**SUSQUEHANNA STEAM ELECTRIC STATION
RESPONSE TO REQUEST FOR ADDITIONAL
INFORMATION ON PROPOSED RELIEF
REQUEST NO. 3RR-18 TO THE THIRD 10-YEAR
INSERVICE INSPECTION PROGRAM
FOR SUSQUEHANNA SES UNIT 2
PLA-6810**

Docket No. 50-388

**Layout drawing, Reactor Vessel Shell
Unit 1 and 2**

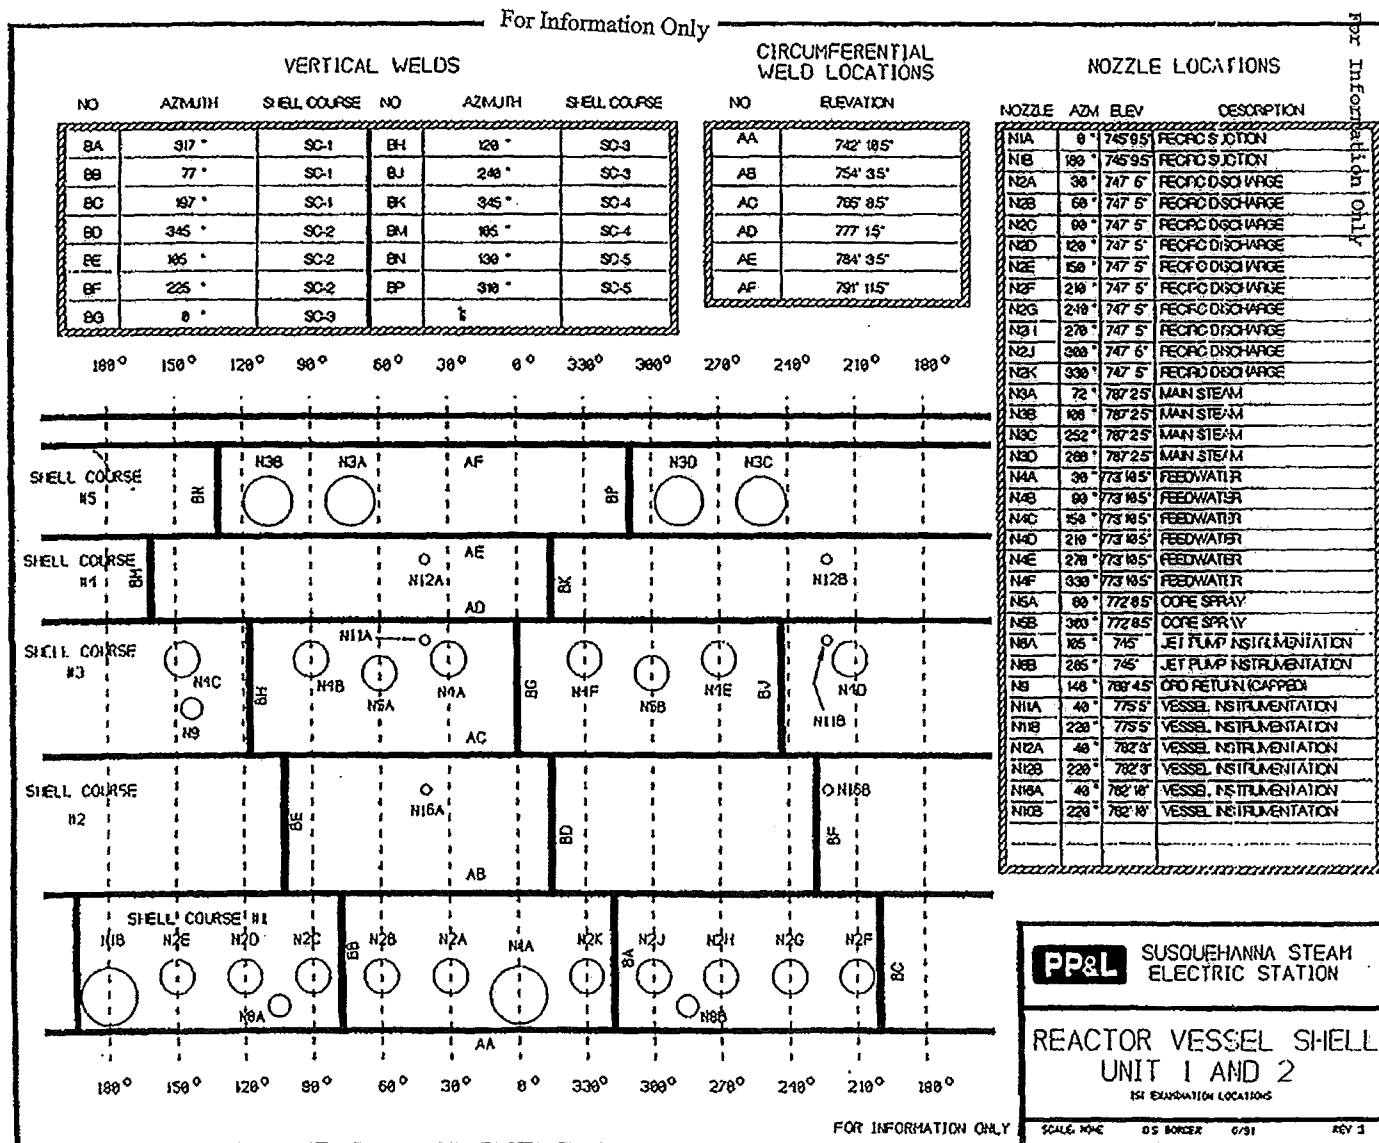
Provide a complete description of the subject weld (inspection category and item no.), the materials of construction, and its location in the system.

The AF weld is classified as an ASME Section XI Category/Item B-A/B1.30 weld. One third of this weld is volumetrically examined every inspection period. This weld connects Shell Course 5 (external reactor vessel) to the Shell Closure Flange. The weld is located at elevation 791', 115" (59'-7 19/32" from vessel zero). Per PPL Susquehanna FSAR, Rev 62, Table 5.2-4, the Shell Closure Flange is a Forge Ring made of Low Alloy Steel, SFA-508, Cl.2. The weld also consists of low alloy steel, SFA-5.5.
